# UNITED STATES PATENT AND TRADEMARK OFFICE

APPLICATION NO.	FILING DATE	FIRST NAMED INVENTOR	ATTORNEY DOCKET NO.	CONFIRMATION NO.
10/812,222	03/29/2004	Gary W. James	METZ 2 00010	3032
27885	7590	10/17/2006	EXAMINER	
FAY, SHARPE, FAGAN, MINNICH & MCKEE, LLP 1100 SUPERIOR AVENUE, SEVENTH FLOOR CLEVELAND, OH 44114			WILKENS, JANET MARIE	
			ART UNIT	PAPER NUMBER
			3637

**Office Action Summary**

FIG. 1

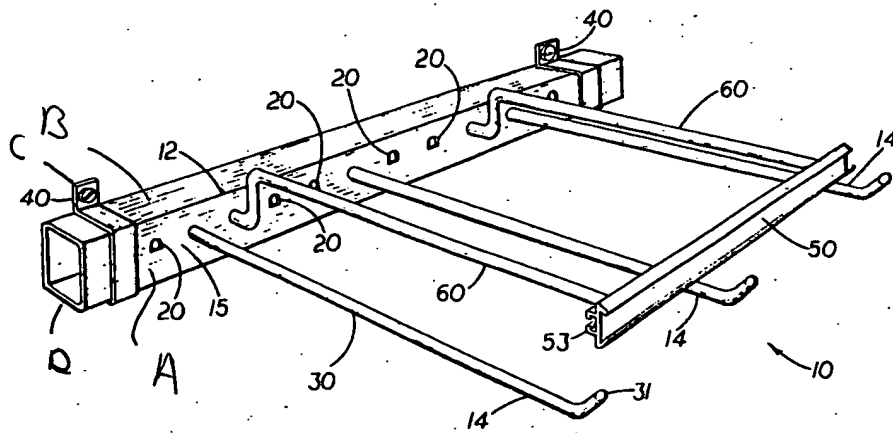
Claims 1-5 are rejected under 35 U.S.C. 102(b) as being anticipated by Fredrickson (4,606,466). Fredrickson teaches an adapter (Fig. 1; see Attachment A) comprising: a first wall (A) having "generally" circular openings (20), a second wall (B) depending normally from a first end (which is parallel to the longitudinal axis of the first wall) of the first wall, a third wall (C) extending from the second wall and being parallel to the first wall, a fourth wall (D) depending normally from a second end (which is parallel to the longitudinal axis of the first wall) of the first wall, and a fifth wall (E) extending from the fourth wall and being parallel to the first wall. The third and fifth walls include openings (F). Please note: limitations found in intended use/"for" statements have been given no weight in the claims.
